STAFF REPORT	
COMMUNITY DEVELOPMENT DEPARTMENT

HEARING DATE: March 28, 2023

SUBJECT: Newkirk Neighborhood AZ, PP
H-2022-0088

B. Preliminary Plat (dated: 10/21/22) – NOT APPROVED

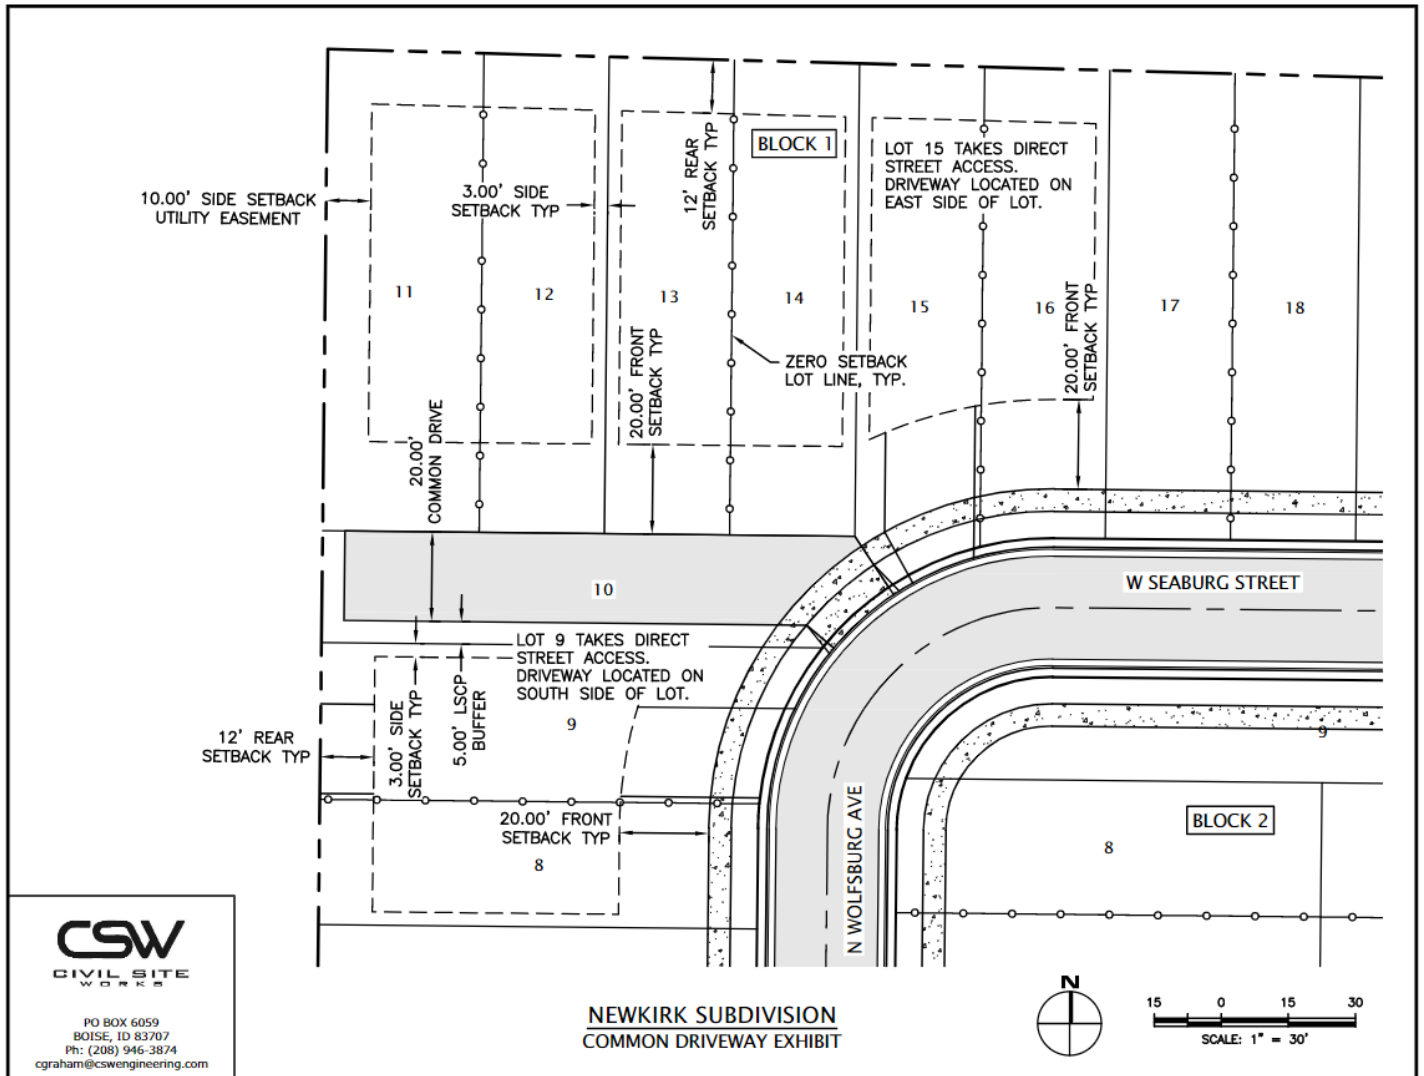
This property and three (3) properties to the south take access from Zimmerman Ln., a private street; two (2) of these properties don't have public street frontage. **ACHD is requiring Zimmerman Ln. to be dedicated and improved as a local public street in order to provide a north/south street connection between Franklin Rd. and the collector street, public street frontage for the two parcels to the south, and access to Ascent Subdivision from a local street, which will enable their temporary vehicle access to be converted to emergency and pedestrian access only. The plat should be revised accordingly.**

Common Driveway (UDC [11-6C-3D](#)): One (1) common driveway is proposed at the northwest corner of the site on Lot 10, Block 1 for access to Lots 11-14, Block 1. Common driveways are allowed to serve a maximum of four (4) dwelling units; in no case shall more than three (3) dwelling units be located on one (1) side of the driveway. **A total of four (4) dwelling units are proposed on the north side of the driveway; the final plat and common driveway exhibit shall be revised to depict a maximum of three (3) units on one (1) side of the driveway as required; or, alternative compliance may be requested as set forth in UDC [11-5B-5](#).**

D. Landscape Plan – Preliminary Plat (dated: 9/6/2022)

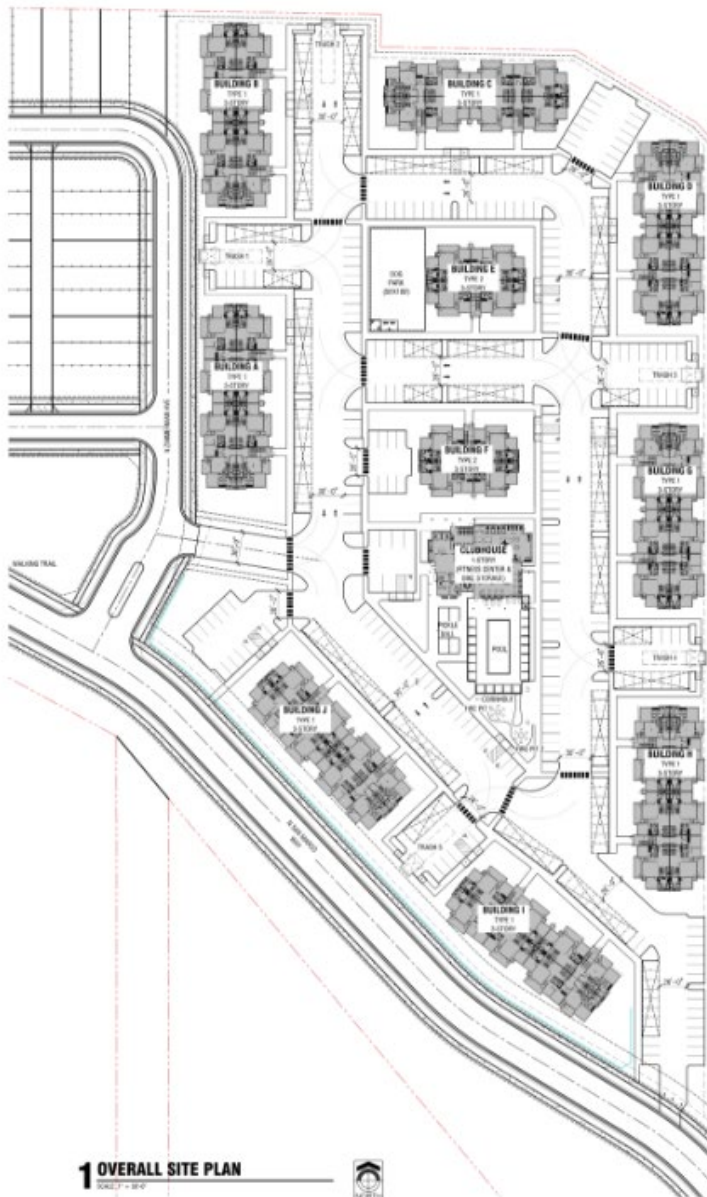
All common open space areas are required to be landscaped with one deciduous shade tree for every 5,000 square feet of area and include a variety of trees, shrubs, lawn or other vegetative groundcover per UDC [11-3G-5B.3](#). **Shrubs should be added to common open space areas and the calculations table on the landscape plan should be revised to include this updated standard; a minimum of 28 trees are required.**

There are several existing trees on this site that will be removed with development. An existing tree inventory and mitigation plan is included in Section VIII.H. **Mitigation is required to be provided per the standards listed in UDC [11-3B-10C.5](#); calculations demonstrating compliance should be included on the landscape plan submitted with the final plat application.**

3. The landscape plan submitted with the final plat shall include the following revisions:
 - a. Revise the landscape plan consistent with the changes to the final plat listed above.

- b. Include mitigation calculations on the plan for existing trees that are proposed to be removed in accord with the standards listed in UDC [11-3B-10C.5](#) and the exhibit in Section VIII.H.

- c. Depict landscaping within the 20-foot wide street buffer along San Marco Way in accord with the *updated* standards listed in UDC [11-3B-7C](#). An 8-foot wide parkway is required along the collector street planted with Class II trees and a 5-foot wide detached sidewalk per UDC [Table 11-2D-6](#). Include the linear feet of buffer with the number of required vs. provided trees in the Landscape Calculations table that demonstrates compliance with UDC standards.

- g. Change the fencing type along the Kennedy Lateral to 6-foot tall wrought iron in accord with UDC [11-3A-6C.3](#).
 - h. Include a picnic table in the common area at the southwest corner of the site on Lot 1, Block 4.

AC5.0
CLUBHOUSE
EXTERIOR ELEVATIONS

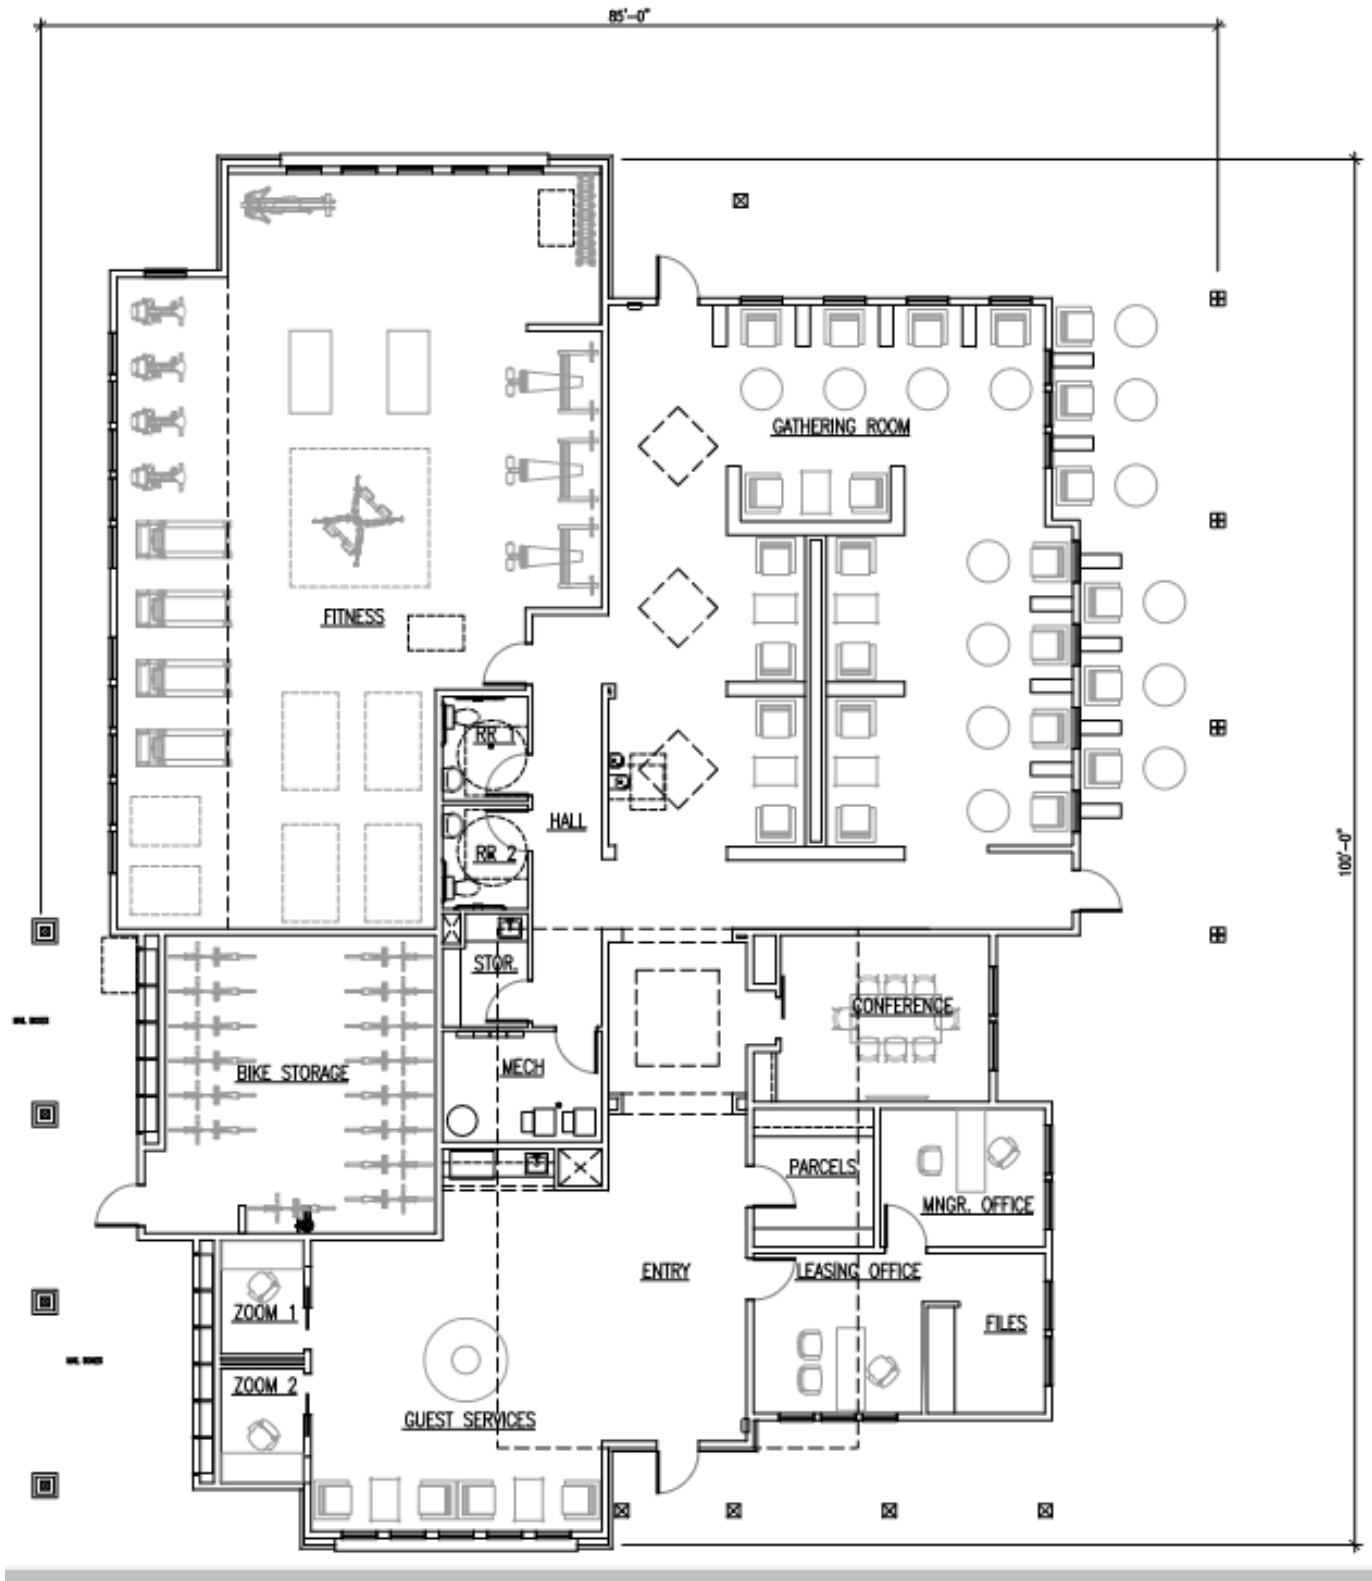
The proposed elevations are ~~not~~ approved in concept however, and they should be revised to incorporate traditional neighborhood design elements as set forth in the TMISAP, as noted above in Section V, and in to comply with the Architectural Standards Manual (ASM). Revised elevations should be submitted that demonstrate compliance with these guidelines and standards prior to Commission action on this application.
